DEVIATION REQUEST AND DECISION FORM

The Hills at Lorson Ranch (CDR 20-007) Pedestrian Ramp Deviation

Deviation for Removing Pedestrian Ramps
The Hills at Lorson Ranch

#1 - SCRUB JAY/GRAYLING

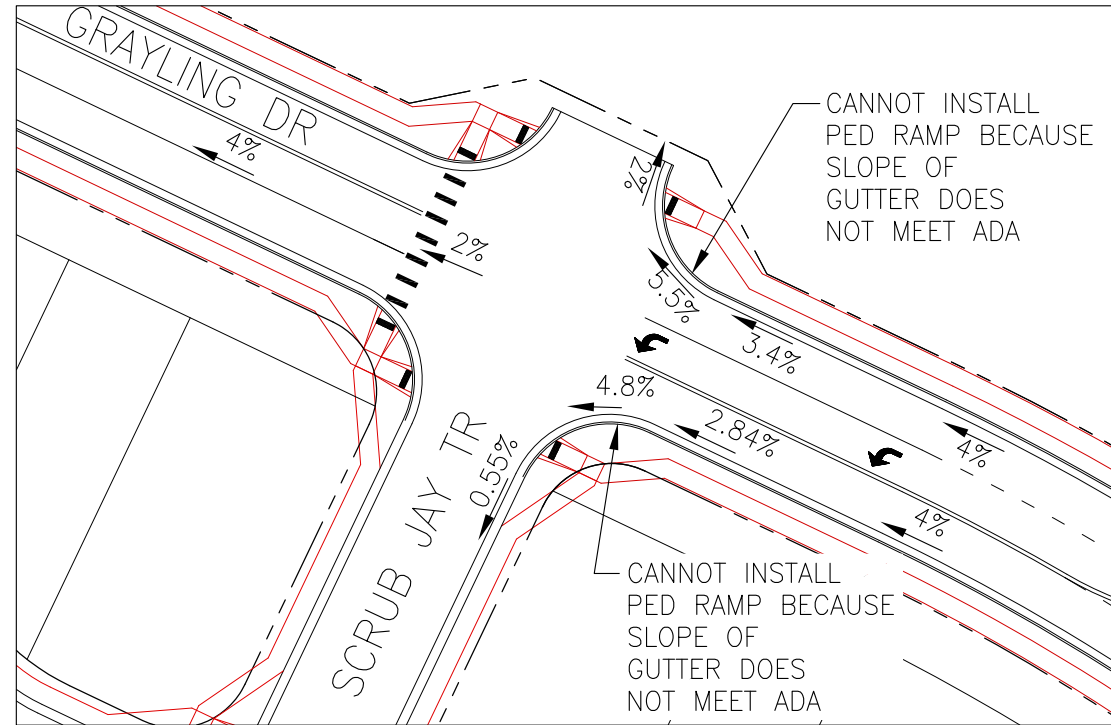
We propose to eliminate the two eastern ramps that provide for a crossing of Grayling Dr (collector street) at Scrub Jay Trail which does not have a stop condition.

Elimination of the two ramps is requested to improve the safety of the intersections and to provide crossings that meet ADA slopes. We propose to eliminate two of the pedestrian ramps which cross streets that do not have a stop condition.

This request has been determined to have met the criteria for approval. A deviation from Section 2.5.2 of the ECM is hereby granted based on the justification provided.

#2 - SANDERLING/GODWIT

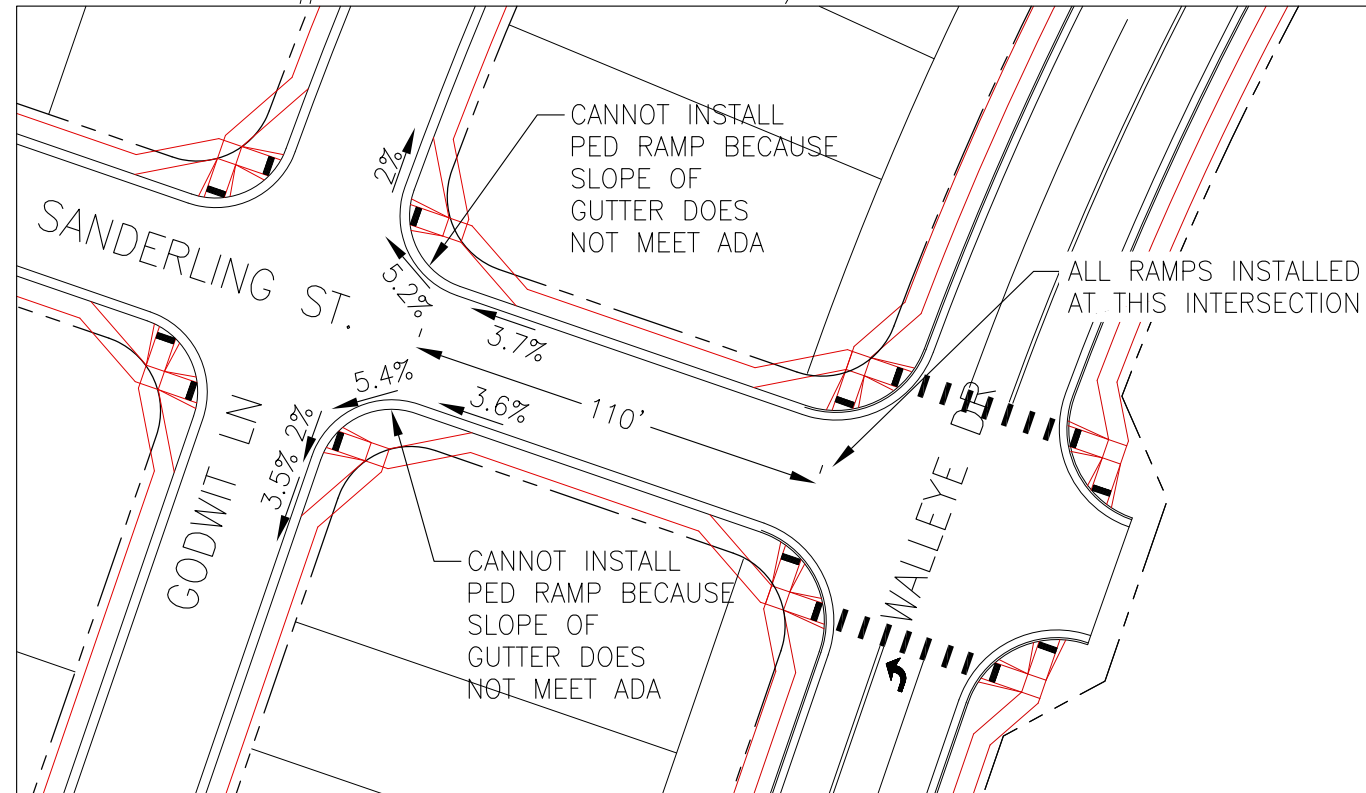
The 4-way intersection ramp elimination also occurs at Roundtail Way/Lake Trout Dr, Roundtail Way/Splake St and Godwit Ln/Sanderling St. All these streets are local streets.
